Winston Churchill Windows Replacement

Addendum No. 1

Project: 2022 Window Replacement – Sir Winston Churchill PS
9 Ardglen Drive
Brampton, ON, L6W 1V1

Reference: SG-555-21/22

Figure 1: Railing Detail

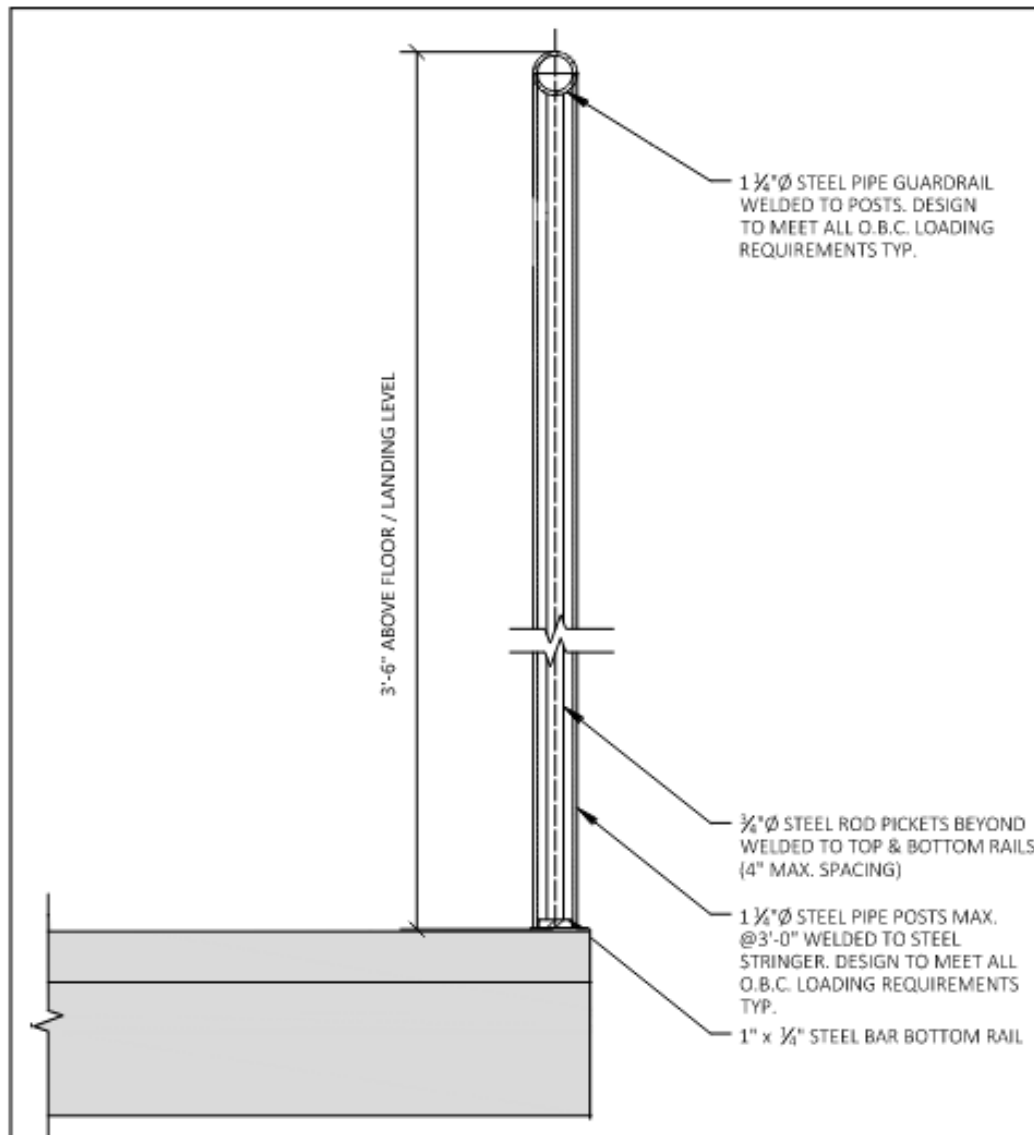
- Per Section 01 11 00 – Scope of Work, Line Item 2.1.12: Anywhere there are existing wood sills that extend or are continuous between windows, new Corian sills are to be provided. Where existing wood sills are provided at individual windows, new Corian sills are to be provide only for the depth and width of that individual window.
- Per Section 01 11 00 – Scope of Work, Line Item 2.1.16: for Window W1, new engineered metal railings are to be provided similarly to the railing shown below in Figure 1. It is to satisfy current requirements of the O.B.C. Engineered stamped shop drawings are to be submitted to Consultant for review prior to fabrication.
